Work Order ID 129294

Item Name: Crosstube Turning Detail

DART AEROSPACE LTD		Work Order:	129294
Description: Crosstube Assembly		Part Number:	D407-667-145
Inspection Dwg: D407-667-145 Rev: C		Page 1 of 2

DRAWING NO. D407-667-145	TITLE CROSSTUBE ASS'Y (407 HIGH FWD)	REV. C	DART AEROSPACE LTD ENGINEERING ORDER		D.E.O. NO. D407-667-145-C-2	SHEET NO. SHEET 1 OF 1	SCALE NTS
DRAWN AJS	CHECKED	MFG. APPR. <i>E</i>	APPROVED <i>AP</i>		DE APPR. <i>[Signature]</i>		
DATE 12.08.02	DATE 12.08.02	DATE 12.08.02	DATE 12.08.02		DATE 12.08.02

DETAIL P
BONDING STRAP INSTALLATION 2 PL

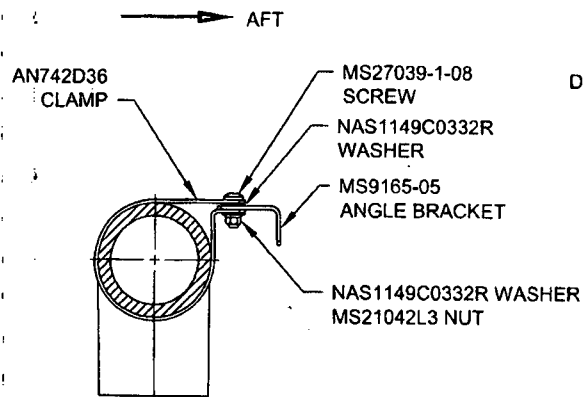
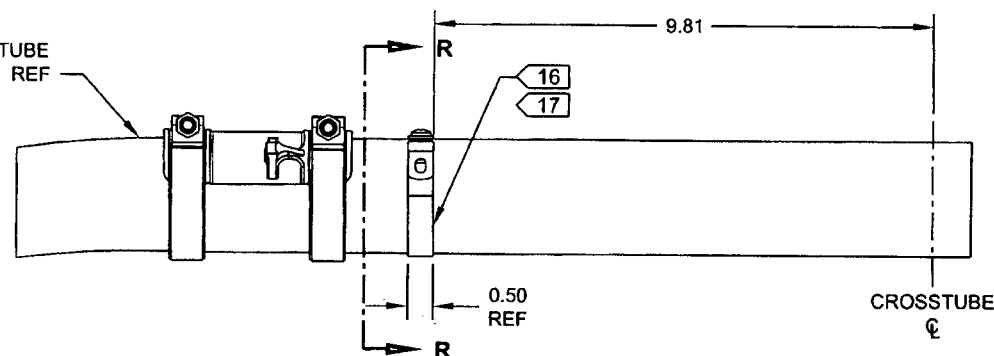
ADD ELECTRICAL GROUNDING STRAP

ITEM	QTY -145	PART NUMBER	DESCRIPTION
1	X	D407-667-145	CROSSTUBE ASSEMBLY (407 HIGH FWD)
⚡			
10	2	AN742D36	CLAMP
11	2	MS9165-05	ANGLE BRACKET
12	2	MS21042L3	NUT (OR MS21042-3)
13	2	MS27039-1-08	SCREW
14	4	NAS1149C0332R	WASHER (OR AN960C10L)

- 16) MASK AREA UNDER CLAMP PRIOR TO PAINTING
- 17) SEAL EDGES WHERE AN742D36 CLAMP MEETS WITH THE CROSSTUBE USING SIKAFLEX-241/-291 OR MIL-S-8802 CLASS B2 OR PROSEAL 890 SEALANT
- 18) PERFORM RESISTANCE CHECK TO ENSURE MAX RESISTANCE IS 10 MILLIOHMS
